DEVELOPMENT DETERMINATION PANEL MEETING

WEDNESDAY 11 JULY 2018

ITEM 3.1	DA2017/1203 - 23 LOCH STREET, FRESHWATER - DEMOLITION WORKS AND CONSTRUCTION OF A DWELLING
REPORTING MANAGER	Anna Williams
TRIM FILE REF	2018/400459
ATTACHMENTS	1 ↓ Assessment Report 2 ↓ Site Plan and Elevations

**MOD2018/0066 - 63 UNDERCLIFF ROAD, FRESHWATER -
MODIFICATION OF DEVELOPMENT CONSENT DA2013/1098
GRANTED FOR ALTERATIONS AND ADDITIONS TO A
DWELLING HOUSE AND CONSTRUCTION OF A SWIMMING
POOL**

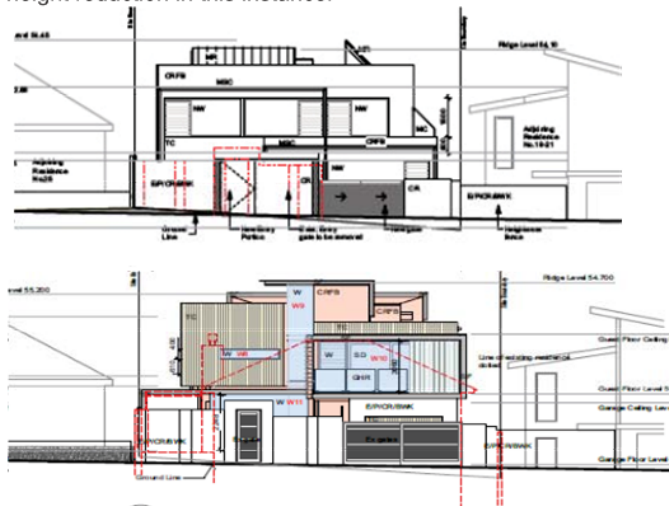
We believe this new proposed development doesn't show any regard or consideration for the current level of shared water views we have. Consequently it will eliminate all the water views which will have a significant negative impact on the current and future value of our property.

We also have concerns that this DA is based on existing and not on original ground levels which will breach Councils maximum building height and envelope regulations. From our observations of the gradual development and changes carried out on this site over the recent years, we question what are the original ground levels that this DA needs to be based on. Height compliance should be measured from the original ground levels and not from any new altered ground level benchmarks.

We therefore request that should the Council support this proposal, it be reduced in height, to ensure our water views are not unreasonably obstructed which will have a negative effect on the current and future value of our property. Specifically it is requested that the ground levels be reviewed and be returned to its original natural line.

Figure 2 - Southern elevation highlighting side boundary envelope and wall height non-compliance

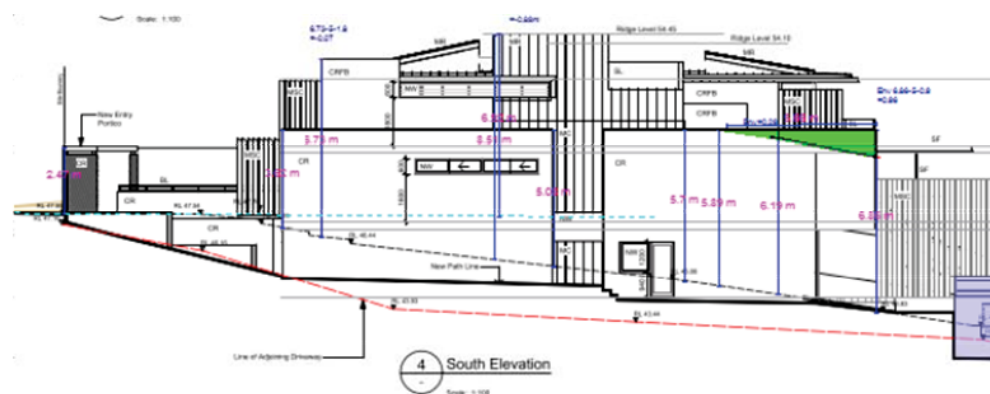
As detailed within the compliance table for the principle development standards and built form controls section of this assessment report, the proposed development complies with the maximum building height of 8.5m. The development results in minor non-compliance with the side boundary envelope and wall height requirement on the south-eastern end of the development (see Figure 2).

The area of non-compliance relates to a section of parapet wall section adjoining the non-trafficable roof area outside the master ensuite. The finished height of this parapet is the same as the front ground floor parapet which is approximately 3.6m high at street level. These non-compliances are not the cause of the view loss and do not create any material impacts in isolation. The complying first floor facade which is higher and wider than the existing single storey hipped roof is the source of the view loss.

The proposed dwelling design on balance is considered a reasonable response to the subject site and its constraints. The resulting view loss would not benefit from amending the design to address the small non-compliances and the view impact in this instance is considered reasonable and acceptable.
